Minutes – Executive Policy Committee – June 11, 2008

Item No. 1 Revisions to the Intersection of Headmaster Row and DeVries Avenue (North Kildonan Ward) File DASZ 20/2004

RE: REVISIONS TO THE INTERSECTION OF HEADMASTER ROW AND DEVRIES AVENUE

REPORT DATE: **May 2nd, 2008**

Figure1: General Layout Drawing DASZ 20/04

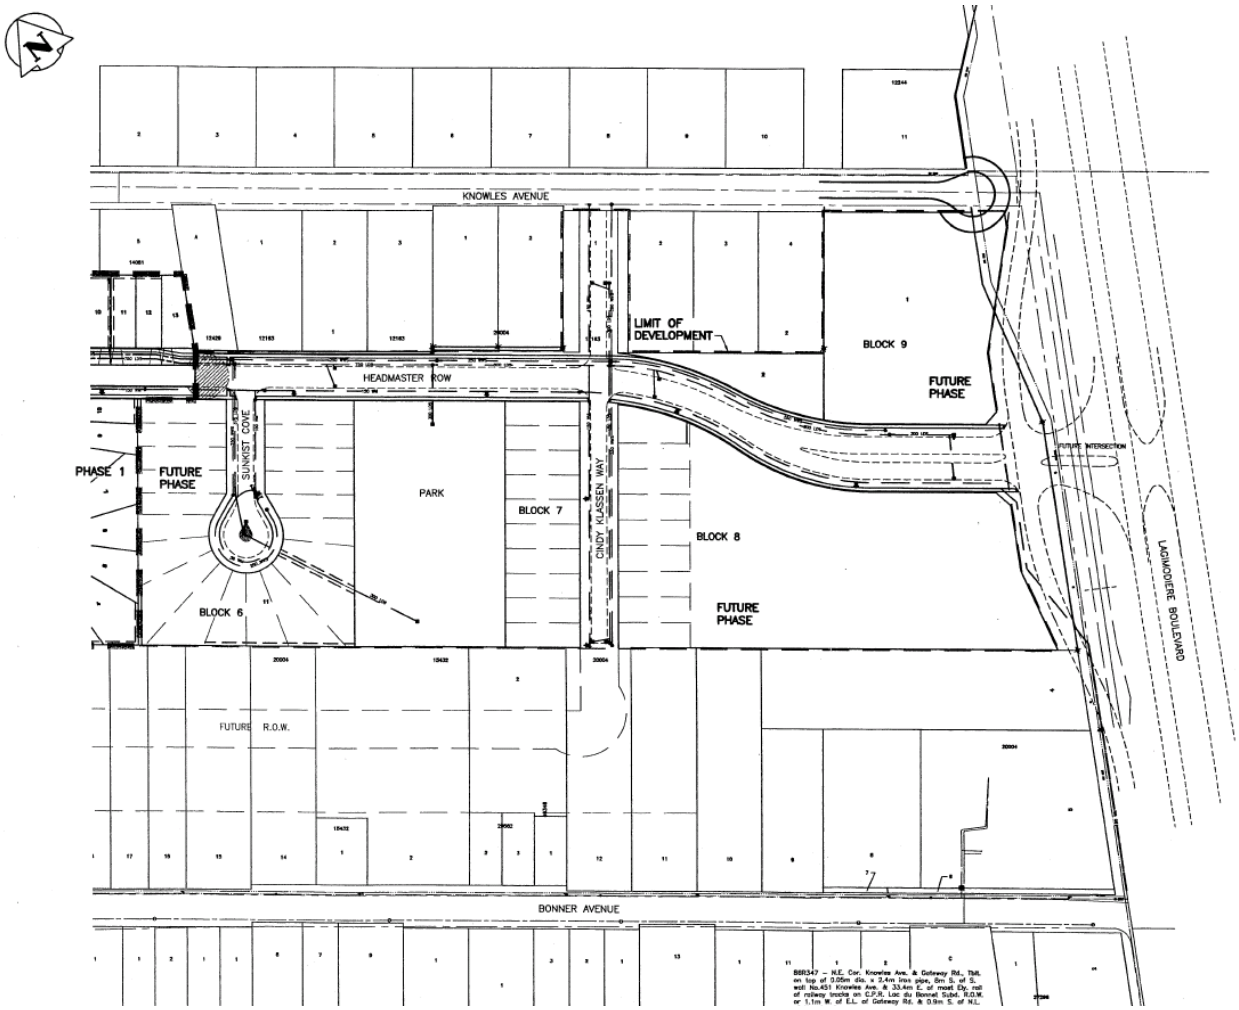
The intersection alignment originally proposed for Headmaster Row at Lagimodiere Boulevard included a north-south service road intersection (DeVries Avenue) on the west side of Lagimodiere Boulevard which is approximately 50m away from the proposed signalized intersection (see Figure 1). This type of close service road alignment has resulted in operational and safety concerns at other locations along Lagimodiere Boulevard including the Springfield Road intersection and the Grassie Boulevard intersection.
